From: Oonagh Kerrigan <Oonagh.Kerrigan@dhaplanning.co.uk>
Sent: 19 June 2026 08:32:39 UTC+01:00
To: "FRS Water and Access" <FRSWaterandAccess@westsussex.gov.uk>
Cc: "Matthew.Porter" <Matthew.Porter@horsham.gov.uk>; "Stephanie.Bryant" <Stephanie.Bryant@horsham.gov.uk>
Subject: RE: DC/26/0355 - Steyning Grammar School
Attachments: 2672ESG-03-01-SK043 RevB - Fire Fighting Tank.pdf

From: Oonagh Kerrigan <Oonagh.Kerrigan@dhaplanning.co.uk>
Sent: 09 June 2026 12:30
To: FRS Water and Access <FRSWaterandAccess@westsussex.gov.uk>
Cc: Matthew.Porter <matthew.porter@horsham.gov.uk>; Stephanie.Bryant <stephanie.bryant@horsham.gov.uk>
Subject: DC/26/0355 - Steyning Grammar School

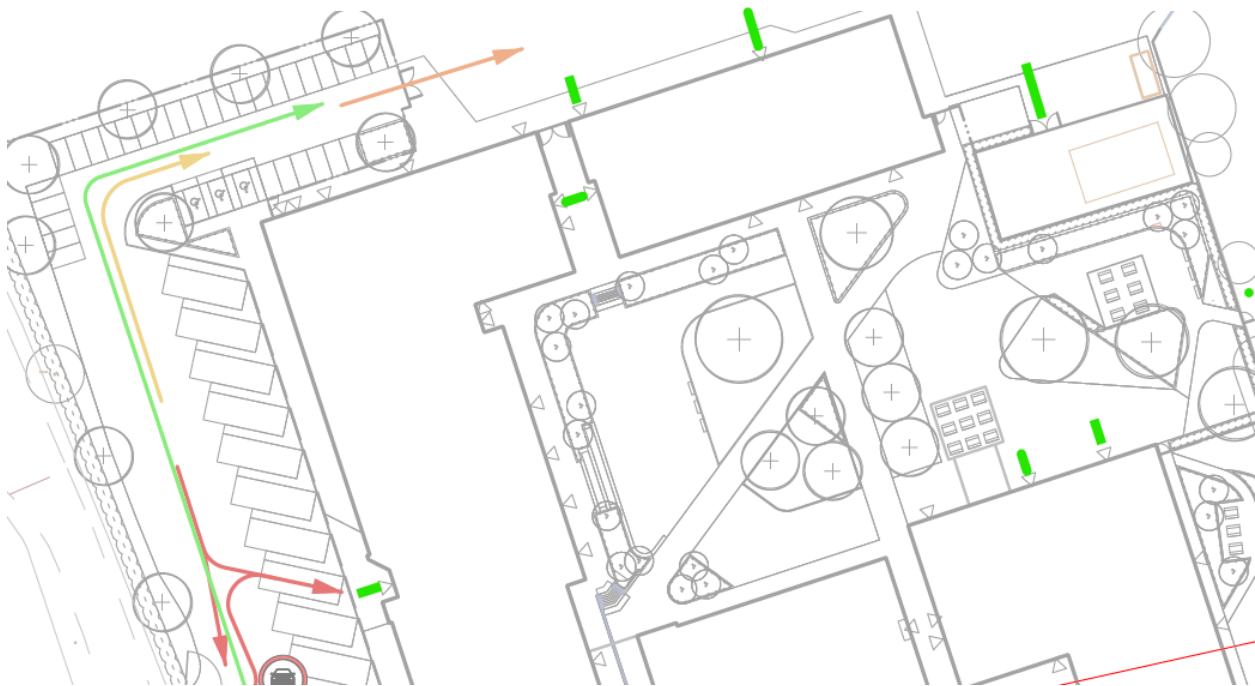
Thank you for getting back to me on this planning application, ?I have responded to the planning officer but probably easier to discuss this with yourself to get the answers. The access for a fire appliance to the water tank looks fine, what we would do in this scenario is probably drop off the light portable pump next to the tank and set it up to extract water and pump it to the fire appliance location. Because our first response firefighting hoses are connected to the fire appliance and all equipment we may require is also carried on the fire appliance, we want this as close to the fire location as possible. That is why I asked for evidence a fire appliance can reach the entrance point to all buildings on site.

I have highlighted (Green lines) some access points to buildings to the north of the site where it is not clear if there is fire appliance access to these entrance points and the distance from the water tank to the fire appliance location for attendance via these access points. I wanted to be

sure that all access points to all buildings are within the required distance from the water supply and the location of the fire appliance, as the main access point may be affected by the fire and require entry from another point in the building.

It wasn't very clear on the plans provided previously, however the building to the north is all one building (Building 13) and separated by an undercroft. This is the same situation for Building 14. We have updated the plan to make it clearer, please see attached.
